Gainesville Renewable Energy Center Completeness Responses and Amendment to the Site Certification Application

Re: Gainesville Renewable Energy Center
Site Certification Application (PPSA No. PA09-55)
Completeness Responses and Amendment to the Site Certification Application

The completeness responses are provided in response to the Florida Department of Environmental Protection (FDEP) Determination that Application is Incomplete dated January 11, 2010. The responses provide additional information and clarifications to the requests from the reviewing agencies, which were included with FDEP's determination of incompleteness. For certain agency requests, GREC LLC clearly indicates the reasons why the requested information is not provided. Also, as indicated in several of the responses, GREC LLC has concluded that certain completeness items may be more suitably addressed through postcertification submittals and has recommended conditions of certification for several of these requests.

TIE TO C2.01 (SHEET 2 of 3)

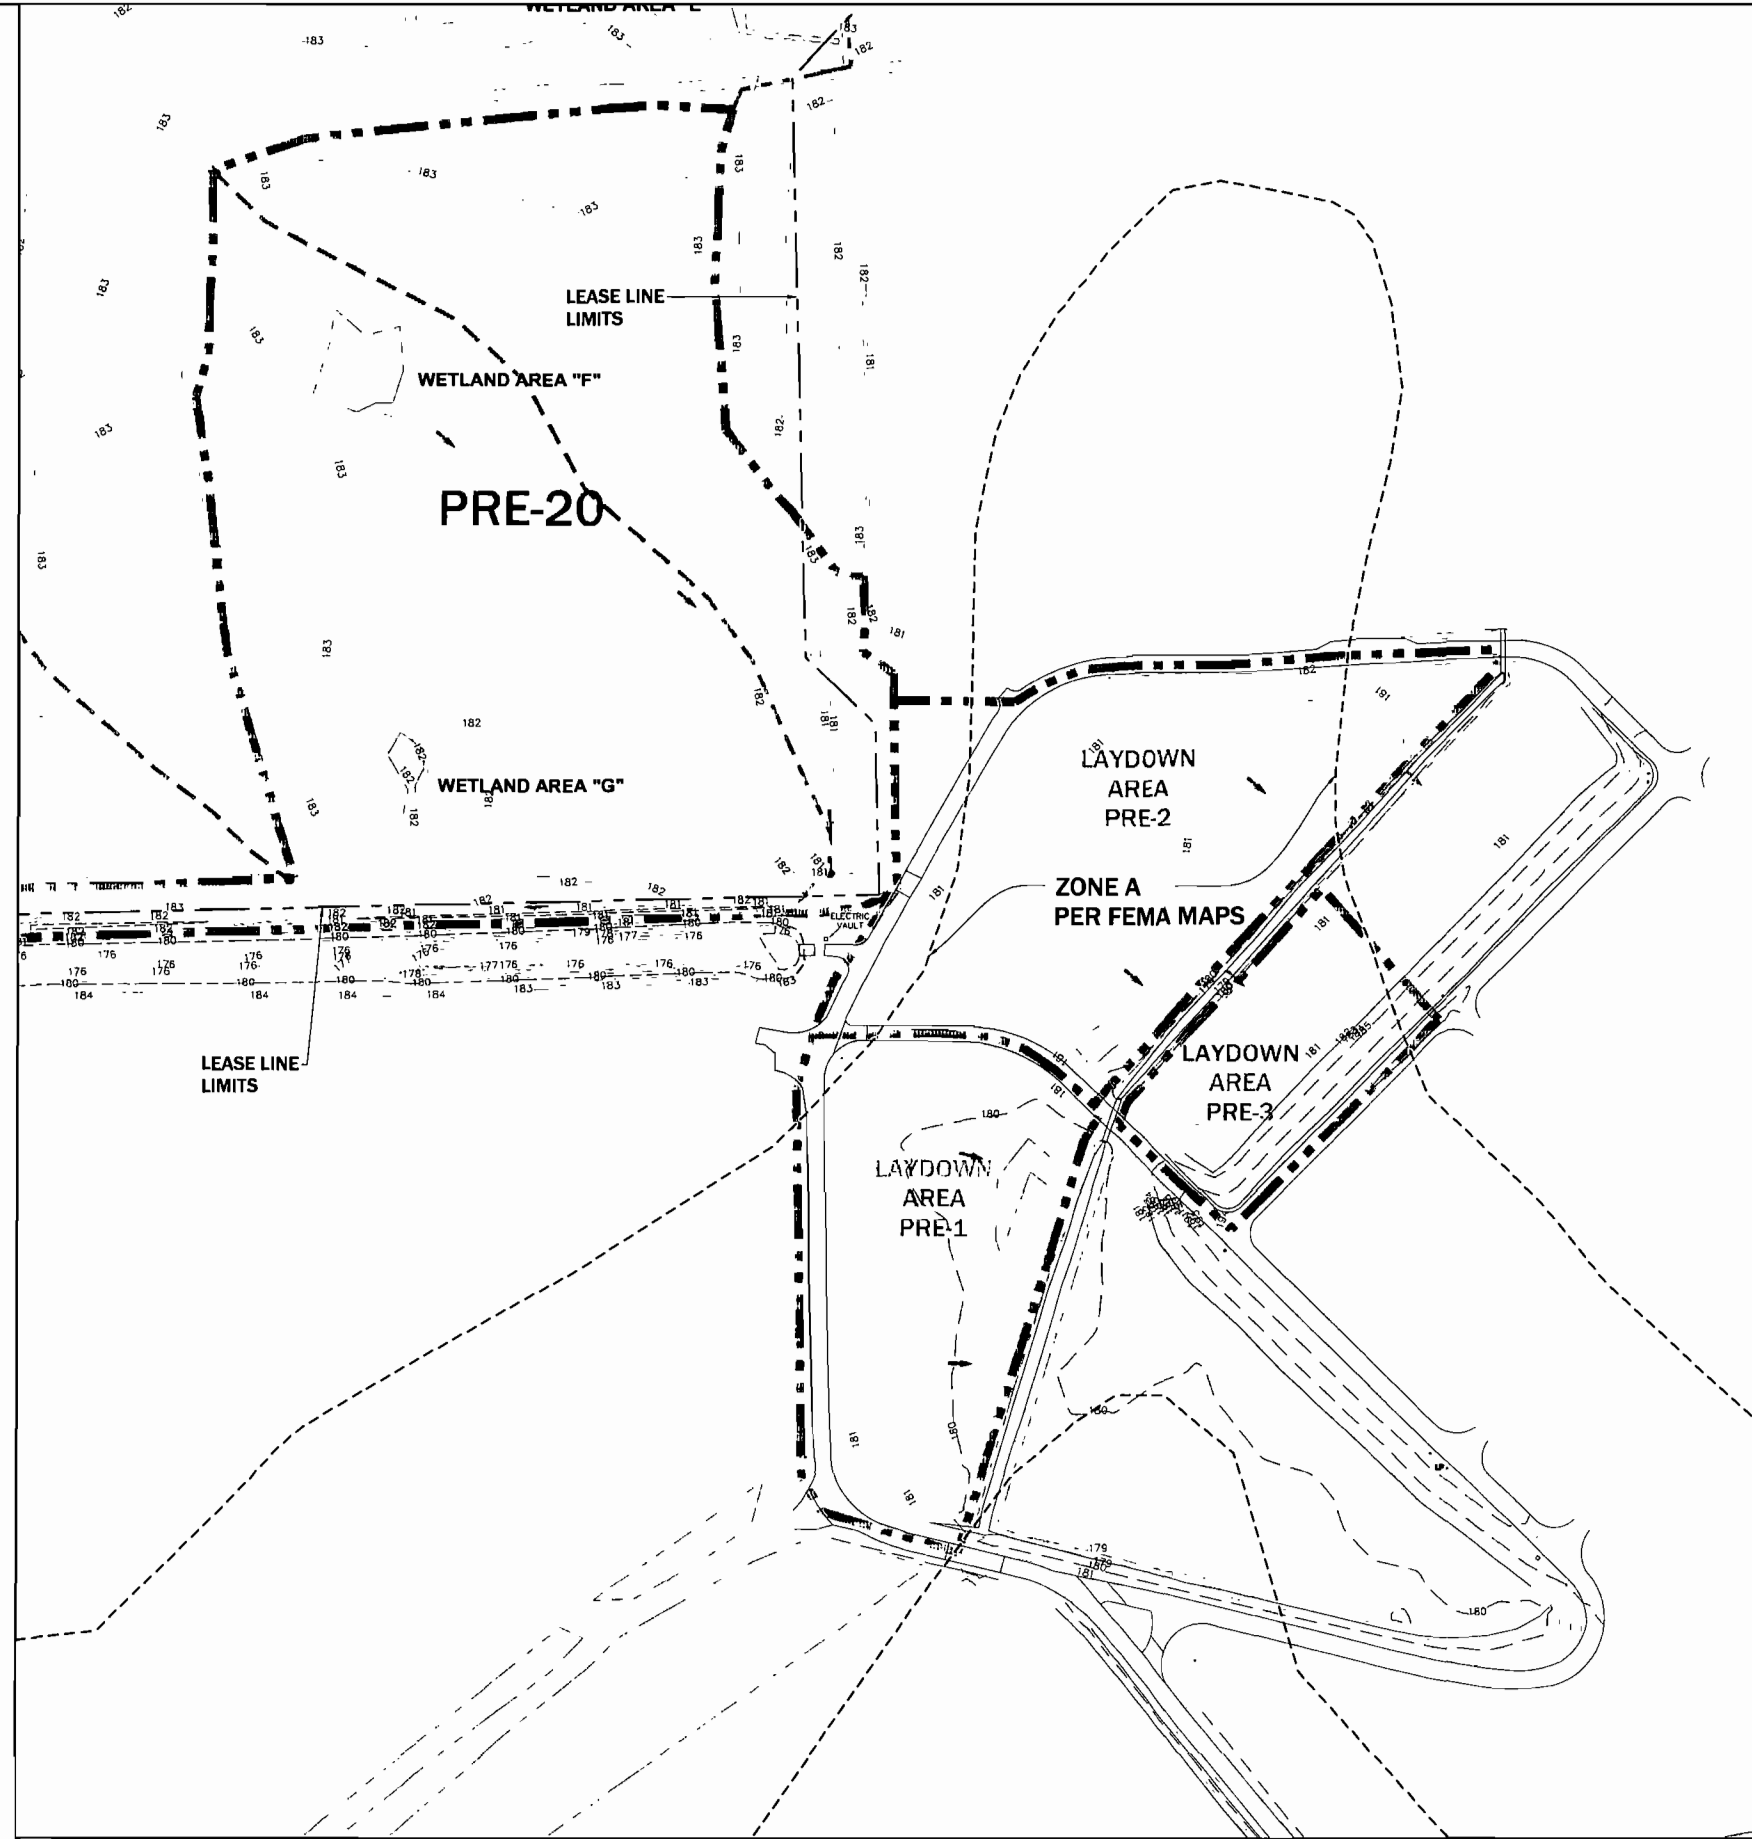
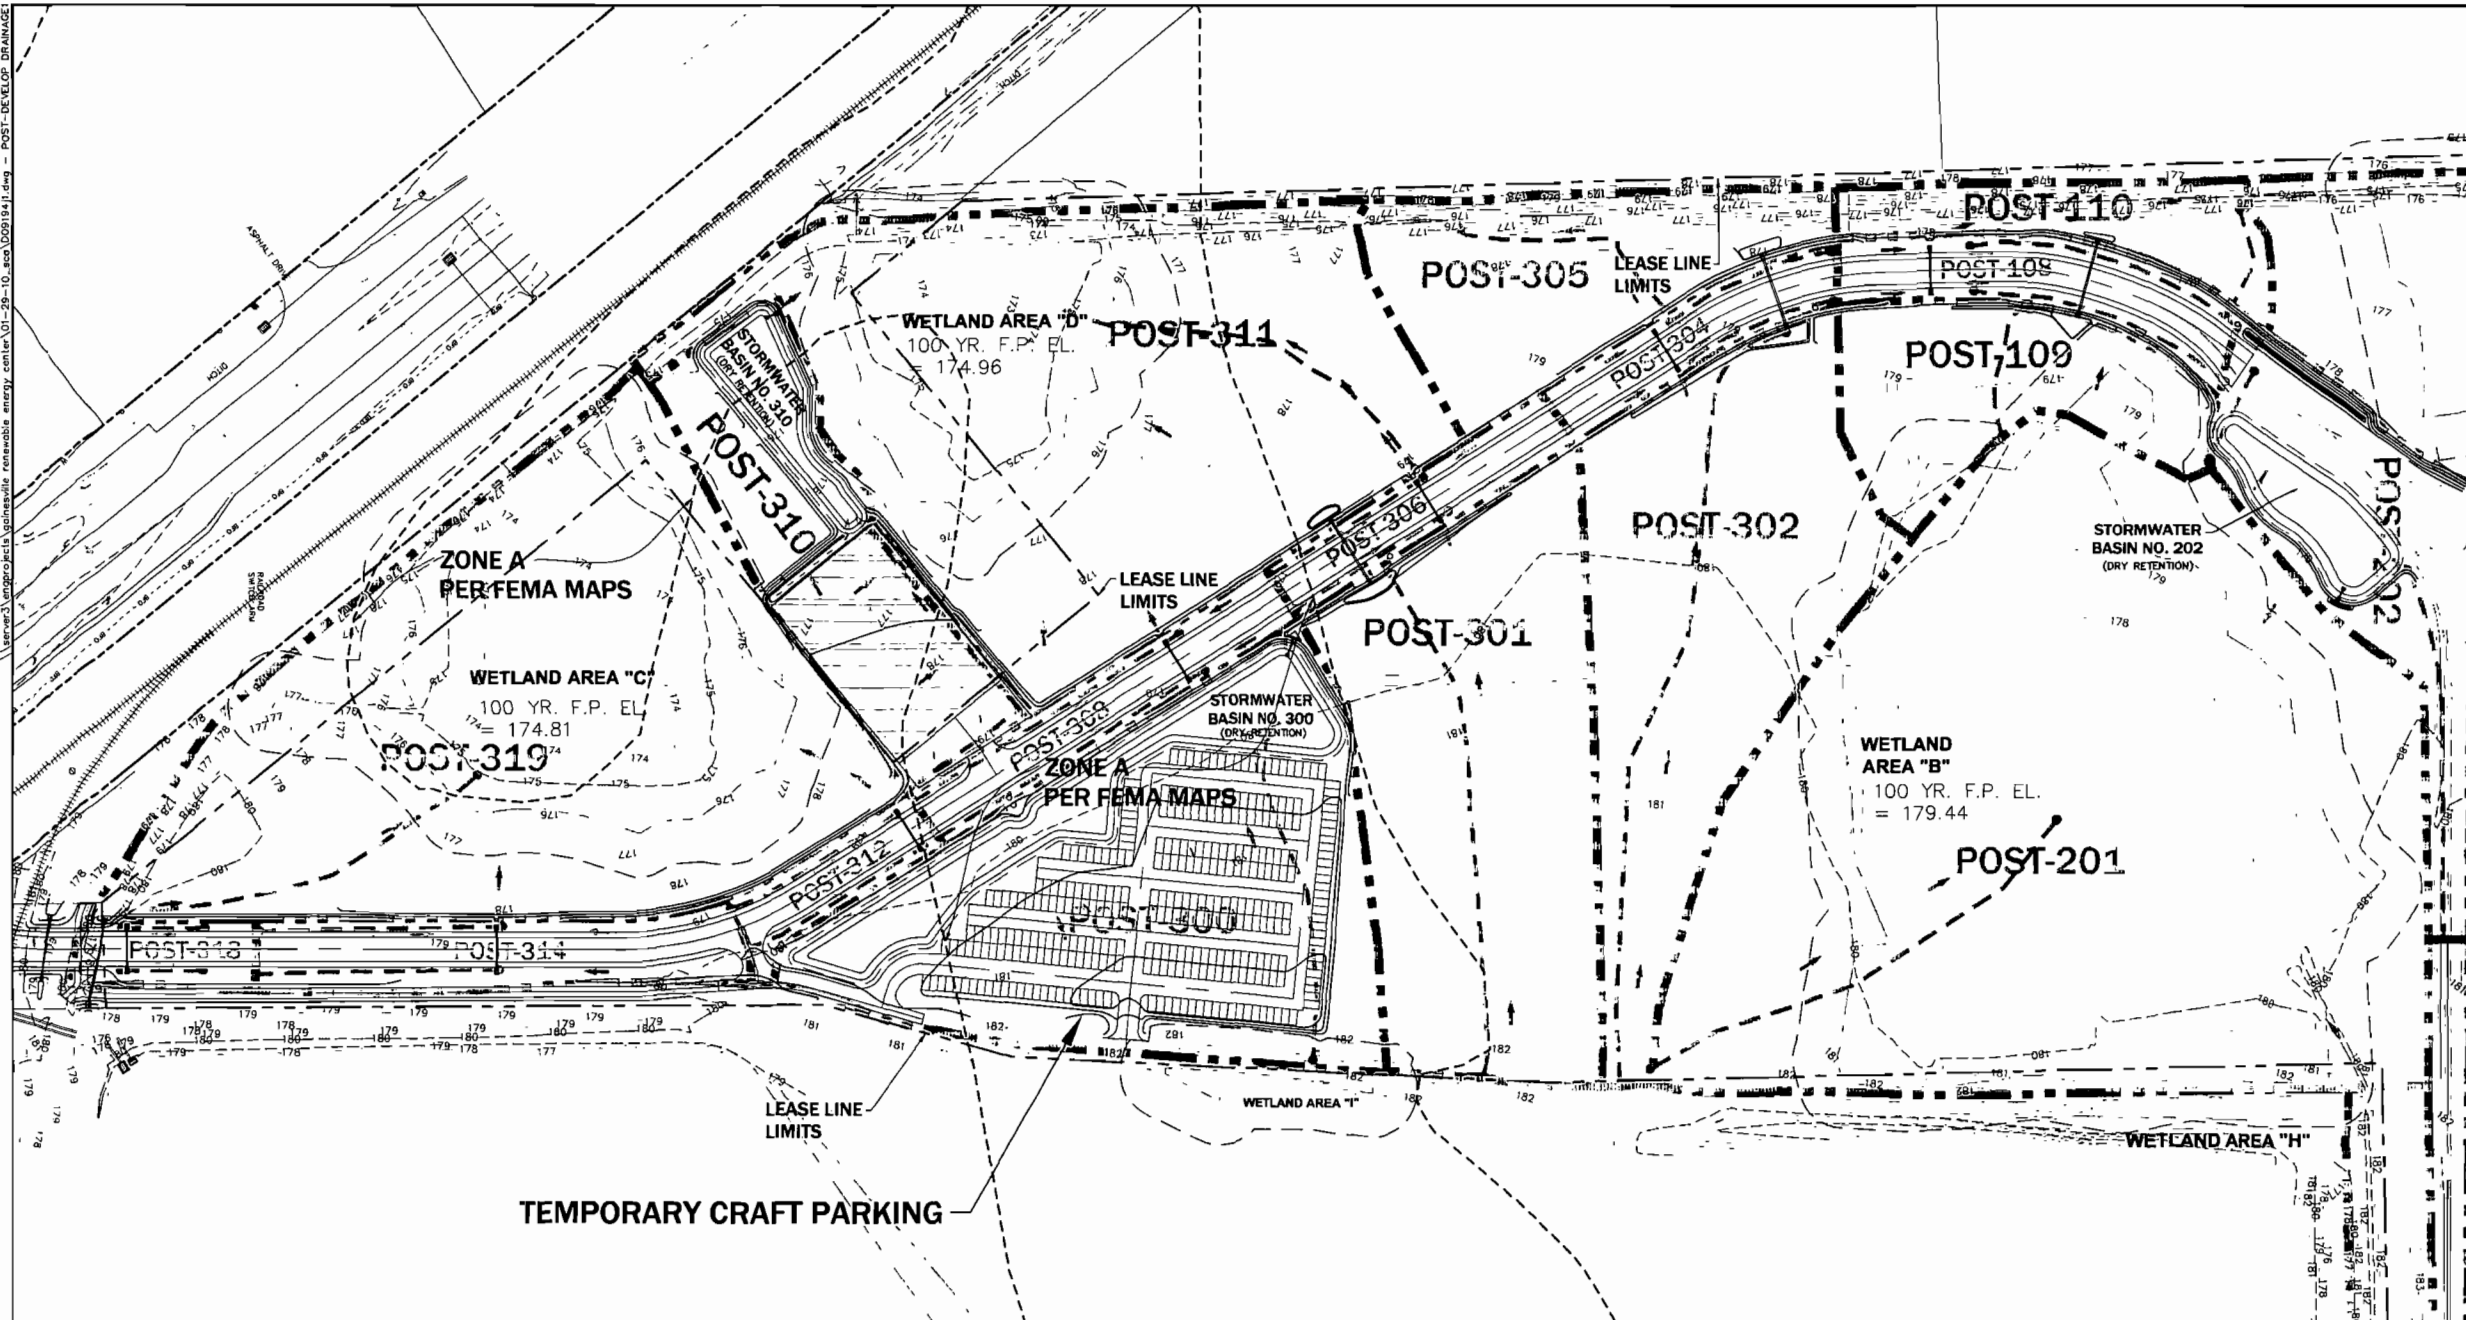
FDEPNEDSW-1 1) Contour lines in the Pre- and Post-development Drainage Maps, Sheets 1 and 2 of 2, found in Volume 2, Appendix 10.4.2, are labeled incorrectly. Please revise.

Referenced datum is North American vertical datum of 1988 (NAVD88) as shown in the notes in the boundary and topographic survey plan, sheet 1 of 5 in Attachment B to this document.

Conveyance of runoff into the proposed stormwater systems is shown in the grading plans (see sheets C2.20, C2.21, and C2.22 in Attachment B). These drawings are also included in the attached CD (stormwater management plan).
